TY·LIN INTERNATIONAL
The stamped documents are hereby:
____ Approved
_X_ Approved as noted
____ Revise and resubmit
See transmittal for additional information as applicable.
This review is for general conformance with design concept only. Any deviation from the plans or specifications not clearly noted by the Contractor has not been reviewed. Review by the Engineer shall not relieve the Contractor of the contractual responsibility for any errors or deviation from the contract requirements.
Josh Olund — Reviewer; 08/18/2016 — Date

Vermont Agency of Transportation
RECEIVED
CK'D BY TYLIN OK'D BY JMF
August 15, 2016
RESUBMIT No — Approved AsNoted
BY Jennifer Fitch DATE 08/18/2016

VT 100 Road Culvert
Duxbury, Vermont

Culvert Layout - Plan and Elevation

Lifting Details

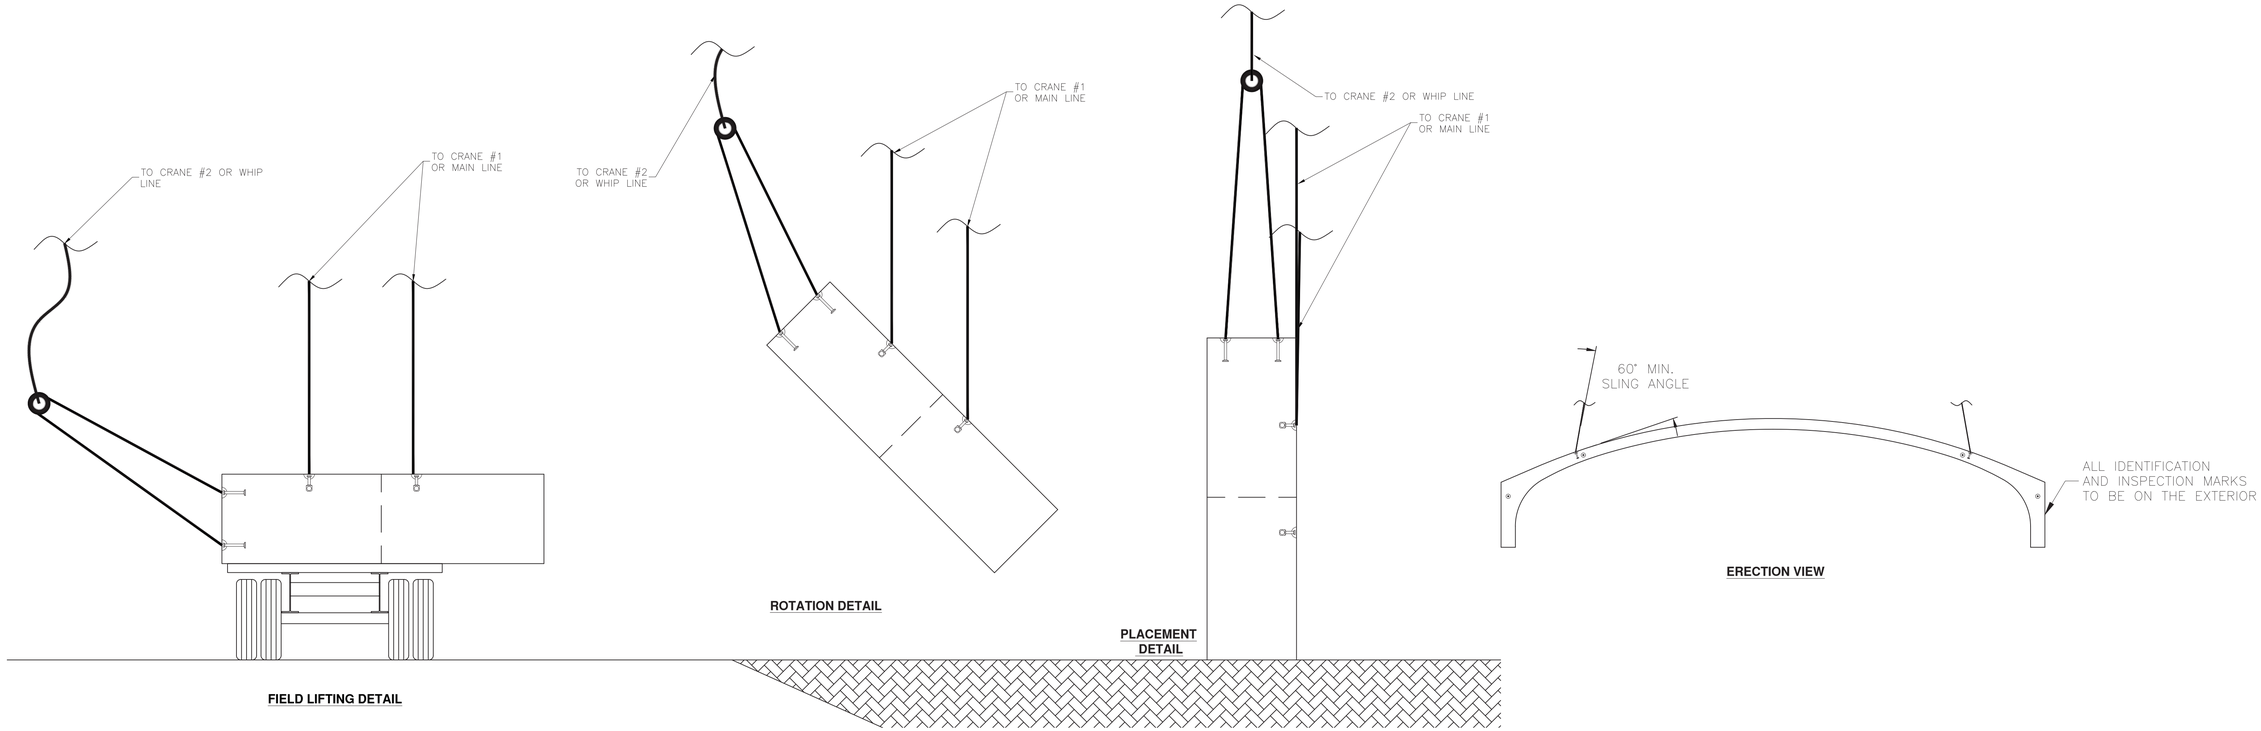
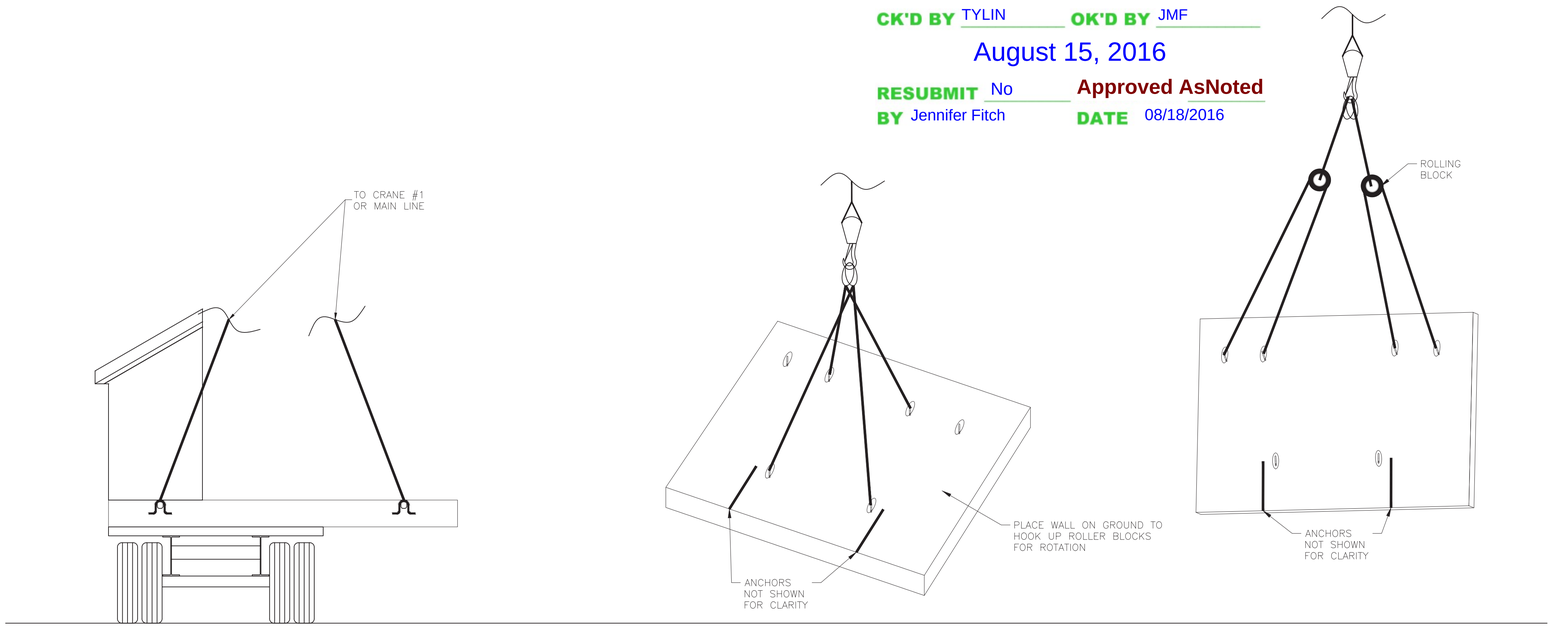
Design of lifting attachments in accordance with Subsections 540.04(h) and 105 is outstanding at this time. However, fabrication in accordance with these plans may proceed at the Fabricator's option with future submittal of the lifting device calculations.
